5 Branch Hill,  
NW3 7LT

Basement Impact Assessment  
Audit

For  
London Borough of Camden

Project Number: 12727-69  
Revision: F1

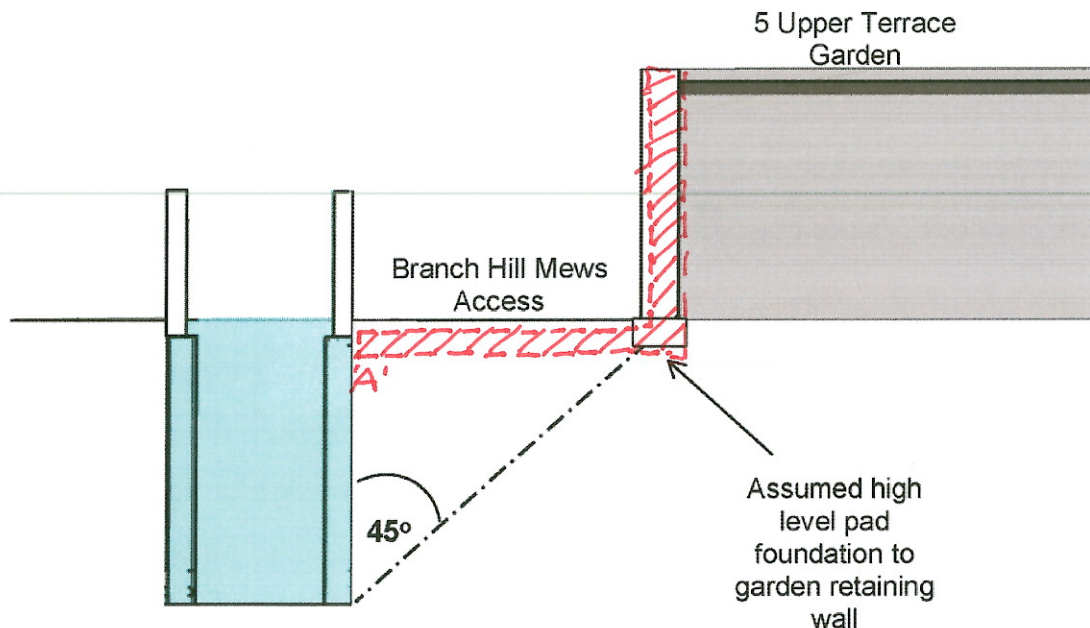
The BIA produced makes reference to existing structure on the land of Branch Hill Mews. "Assumed high level pad foundation to retaining wall". This assumption is incorrect. The wall is not constructed as assumed which may effect on the proposed methods of construction and calculations.

The retaining wall to the property known as 5 Upper Terrace was constructed in an 'L' formation with the base leg of the L forming the road foundation level as shown in RED on the attached extracted section drawing. The existing is not as illustrated on page 35 (LBH4523) which forms part of the current application.

The 'L' shaped R.C. Retaining wall runs the width of the Branch Hill Mews access road and it is my understanding that the maximum resultant over turning pressure on the soil will be at the junction of the underpinning ('A' marked on the drawing attached) and that this must be taken into consideration in any design and construction sequence. Sliding of the wall may also be an issue.

Where information on the configuration of neighbouring structures is uncertain, we are required to adopt worst case assumptions and this is the case in regards to the retaining wall to the rear garden of 5 Upper Terrace.

It can be stated that the presence of a reinforced concrete L-shape structure as now reported will provide substantially greater rigidity to the situation (in both plan and section) than that which has been assumed in the BIA and is to be welcomed.

Rest assured that care has been taken to ensure that full lateral support for the carriageway of Branch Hill Mews will be maintained throughout both the temporary condition and also in the permanent situation, and that a scheme of structural monitoring will be agreed between the party wall surveyors in order prevent any movement in excess of that which has been predicted.

In practice, should the monitoring pick up any movement, the amount and loading of the temporary horizontal propping ( shown on page 28 et seq of the BIA) would simply be increased as necessary to prevent any movement of Branch Hill Mews and, in turn, of the retaining wall to the rear garden of 5 Upper Terrace.
